3. Fernwood Subdivision 2024; KPB File 2024-033 Geovera, LLC / Duncan Location: Fernwood Drive Fritz Creek Area / Kachemak Bay APC

ITEM #3 - PRELIMINARY PLAT SUBDIVISION NAME

KPB File No.	2024-033
Plat Committee Meeting:	April 22, 2024
Applicant / Owner:	Dorothy Duncan of Homer, AK
Surveyor:	Stephan C. Smith / Geovera, LLC
General Location:	Mile 6 East End Road, Fritz Creek Area / Kachemak APC
Parent Parcel No.:	174-380-01
Legal Description:	T 6S R 12W SEC 6 SEWARD MERIDIAN HM 0740937 FERNWOOD SUB UNIT 1
	TRACT 1
Assessing Use:	Residential
Zoning:	Rural Residential
Water / Wastewater	Onsite / Onsite
Exception Request	None

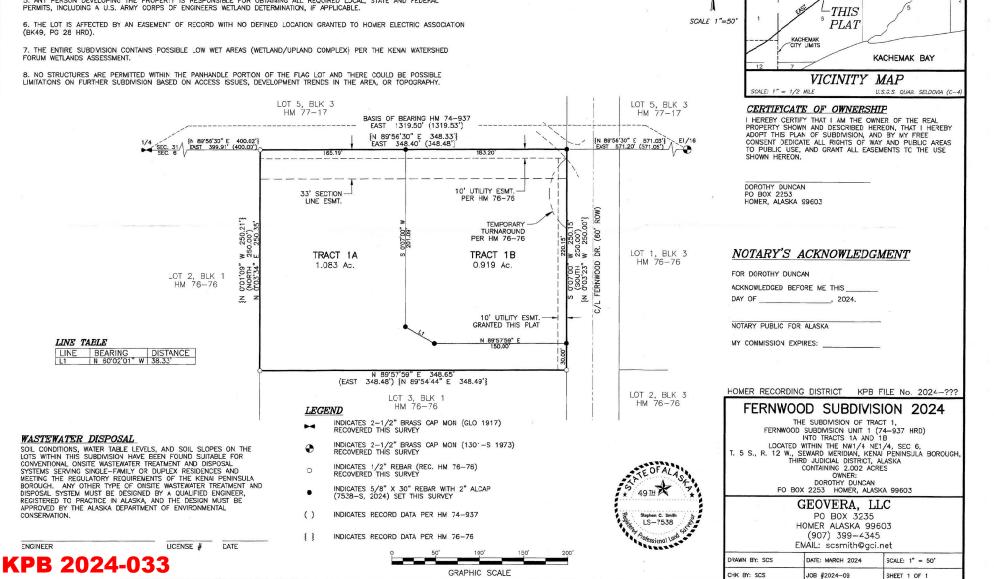
There is a driveway encroachment shown in the northeast corner of the plat. The owner plans to use this access point as the access pint for Tract 1B.

The 20' building setback is noted in the plat notes, it should also be shown on the drawing.

The plat notes identify a blanket easement at plat note 6. The certificate to plat on page one labels it as Volume/page 49/28 but the actual page on the document in the CTP is 284. HEA made the same notation in the comment they sent. Please correct the page in the plat note.

Add to the Plat Approval the date of April 22, 2024

Township to be amended to 6 in the legal description. Change KPB No to 2024-033
